DEVIATION REQUEST AND DECISION FORM

Sterling Ranch Sand Creek Channel Construction Drawing Review CDR 20-4 Project Name:

PCD File No. CDR 20-4

DEV-23-002

Exhibit A
Channel Bottom Access Spacing

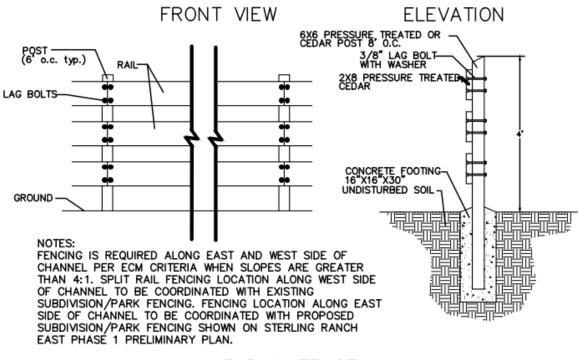
A deviation from the standards of or in Section <u>ECM section 3.3.3 Open Channel Design Standards</u> of the Engineering Criteria Manual (ECM) is requested for the Sand Creek Channel Design – Channel Perimeter Fencing.

Per ECM Section 3.3.3, Item K.4. Fencing is required for all channels abutting residential development schools, parks and pedestrian walkway based on the following criteria;

• All constructed channels steeper than 4:1 where design frequency storm has a velocity that exceed 5 feet per second and 2 feet in depth or a combination thereof, for a factor of ten

When the above condition is met, Fencing shall be chain link, a minimum of 6 feet in height with a top rail and vinyl coated for natural color compatibility (green or brown)
State the reason for the requested deviation: Sterling Ranch is requesting to use a more aesthetically pleasing split rail fence design as shown in exhibit A
Explain the proposed alternative and compare to the ECM standards (May provide applicable regional or national standards used as basis):
The vast majority of the channel side slopes or 4:1 or flatter, however in some isolated areas a 3:1 slope is necessary and those areas will require fencing. When that condition exists Sterling Ranch proposes to use split rail fencing similar to the detail shown in Exhibit A.

Approved by the ECM Administrator			
This request has been determined to have met the criteria for approval. nereby granted based on the justification provided.	A deviation from Section _	3.3.3, Item K.4.	of the ECM is
Approved By: Gilbert LaForce, P.E. Engineering Manager	٦		
L Date: 11/08/2023 9:16:14 AM El Paso County Department of Public Works	Л		
Denied by the ECM Administrator			
This request has been determined not to have met criteria for approval. nereby denied.	A deviation from Section _		_ of the ECM is
Г	٦		
L	Т		
ECM ADMINISTRATOR COMMENTS/CONDITIONS:
